STAFF RECOMMENDATION
1300 Ashwood Avenue
February 20, 2013

Application: Addition—accessory structure and Setback reduction
District: Belmont-Hillsboro Neighborhood Conservation Zoning Overlay
Council District: 18
Map and Parcel Number: 10513002500
Applicant: Blaine Bonadies, Architect
Project Lead: Melissa Baldock, melissa.baldock@nashville.gov

<p>Description of Project: Application is to construct an addition to an existing accessory structure that requires a setback reduction.</p> <p>Recommendation Summary: Staff recommends disapproval of the addition to the accessory structure, finding that the height, scale, and roof shape of the accessory structure is not similar to historic street-facing outbuildings for primary buildings and lots of similar scale and do not meet sections II.B.a, II.B.b, II.B.e. and II.i.1 of the design guidelines. Staff recommends disapproval of the requested setback reduction based on the fact that the reduction will increase the inappropriate perceived massing of the structure. Staff finds that the project does not meet Section II.B. of the <i>Belmont-Hillsboro Neighborhood Conservation District: Handbook and Design Guidelines</i></p>	<p>Attachments A: S

front elevation (facing back of existing house)

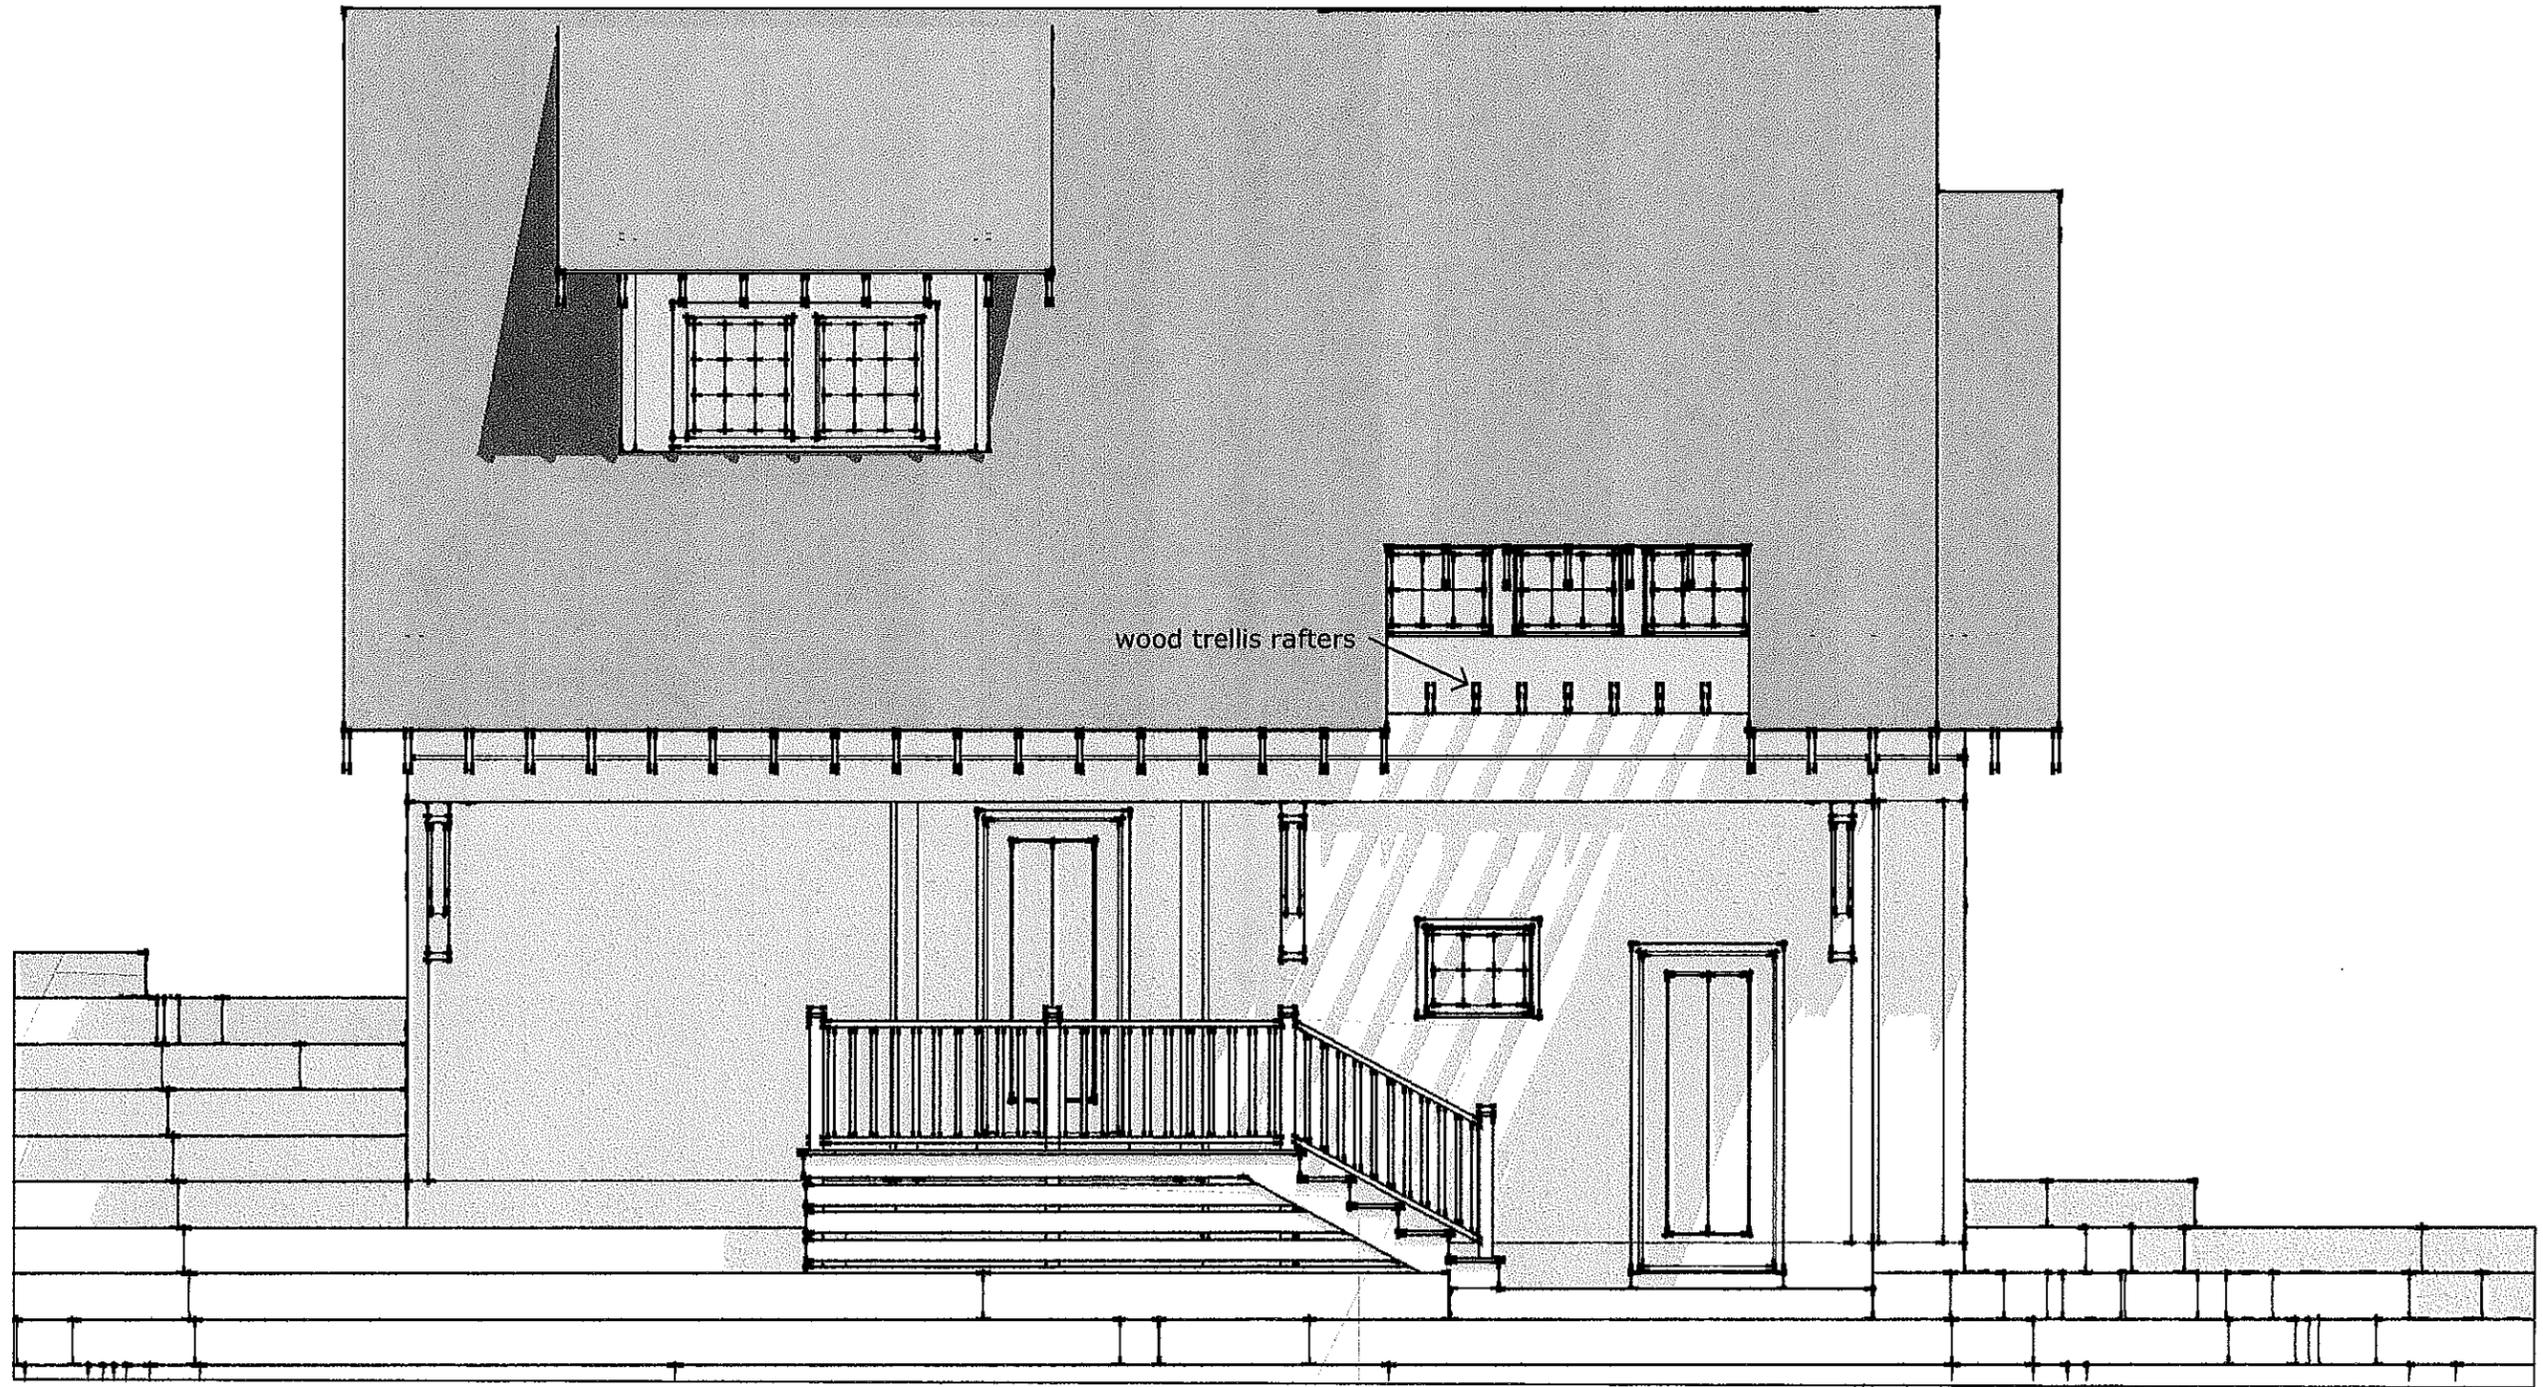
Dormers are proposed for the house-facing and alley-facing roof slopes. The shed dormer that is set back appropriately and an inset dormer are proposed for the house-facing façade. A shed dormer that stacks on the wall below and a wall dormer are proposed for the alley-facing façade. While dormers that are not set back from the wall and wall dormers are typically inappropriate, in the past staff and the Commission have found them appropriate when they face the alley.

right side elevation (along east wood ave) 1/4"=1'

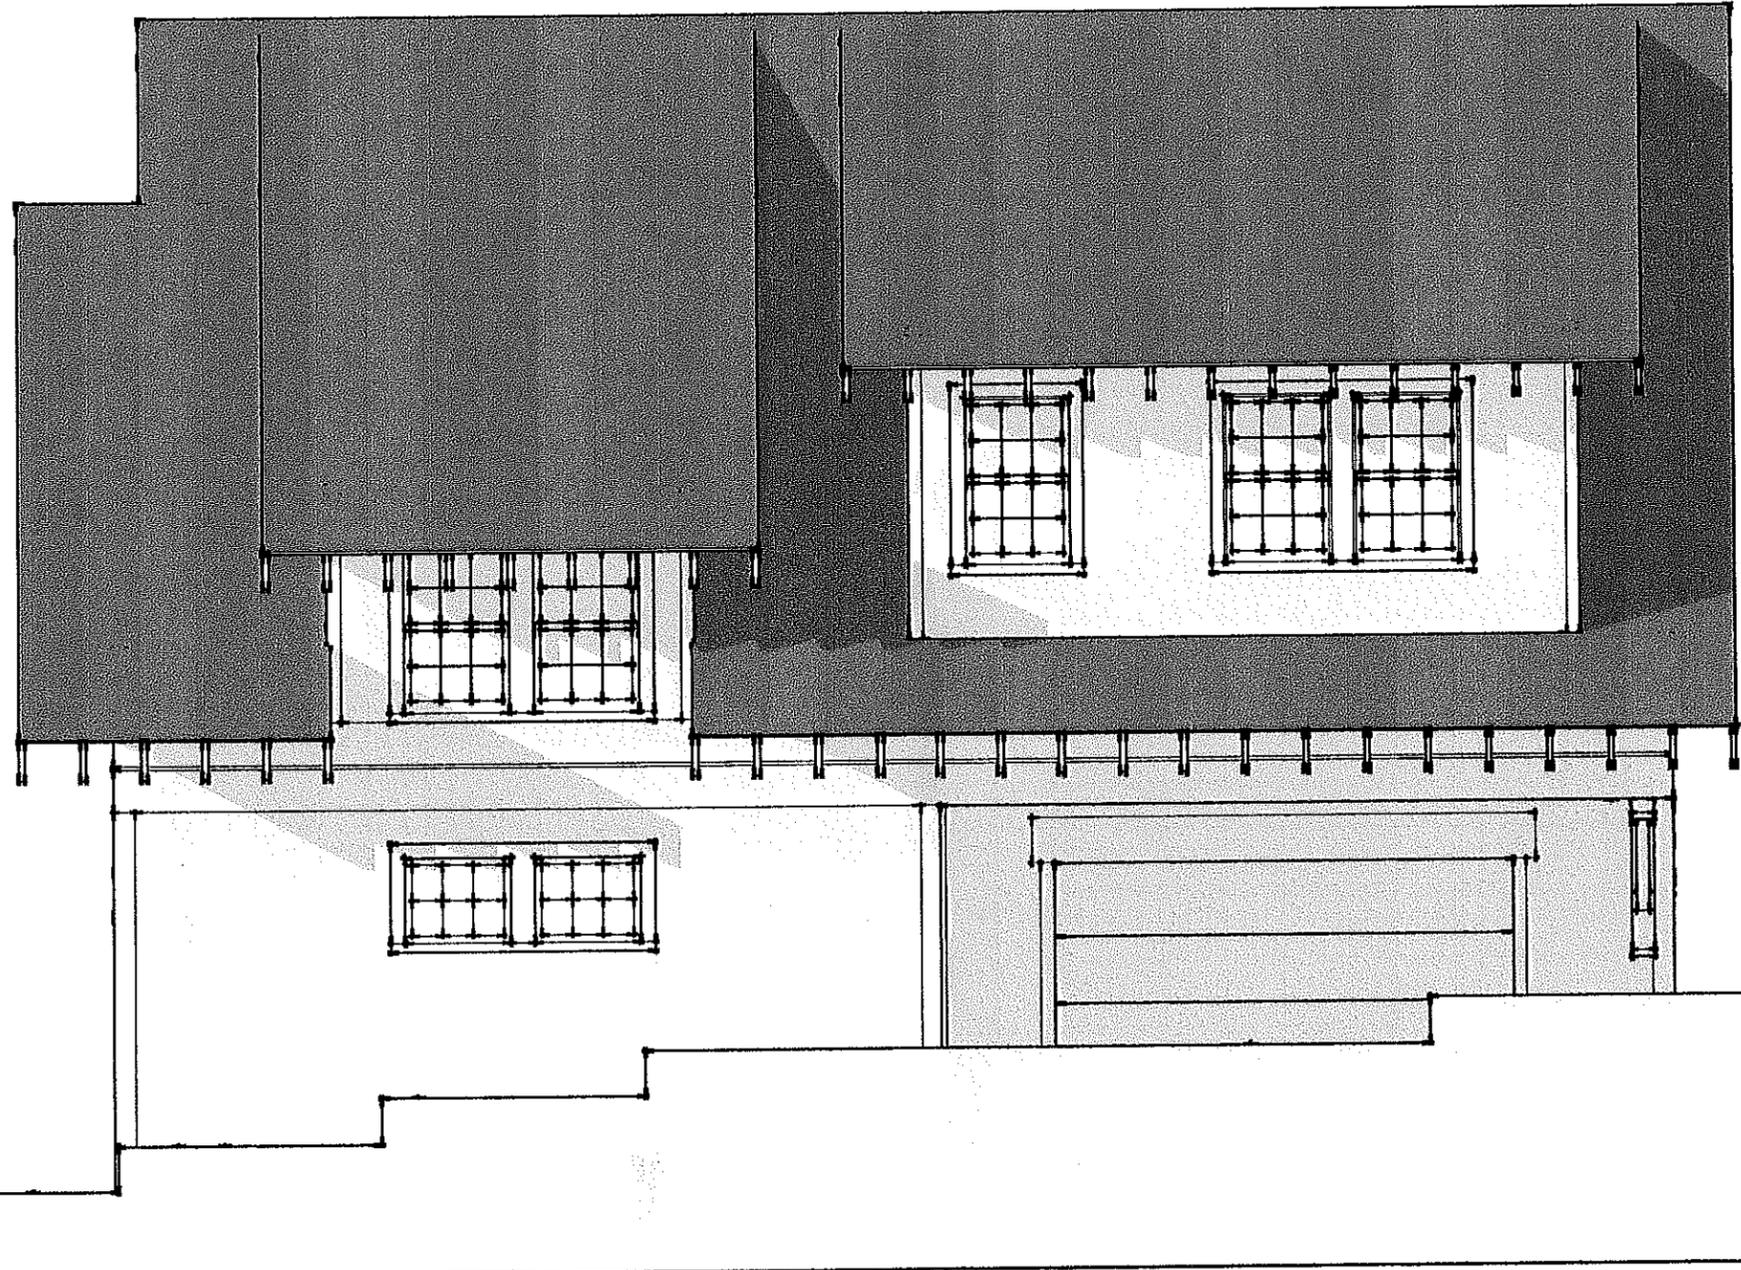
Roof Shape: The existing house has a side gable roof form, with a front slope of 9/12 and a much lower back slope of approximately 3/12. The primary roof form for the accessory structure will be a side gable with a slope of approximately 12/12 (with the gable facing Eastwood Avenue). While a steeper roof slope can be appropriate for accessory structures in some instances, for this project, staff finds that the steeply sloped

roof adds to the height of the structure and contributes to it being out of scale with the historic house. Staff does find that the 12/12 pitch contrasts with the historic house's roof, and therefore that the new accessory structure does not meet Sections II.B.e and II.B.i.1 of the design guidelines.
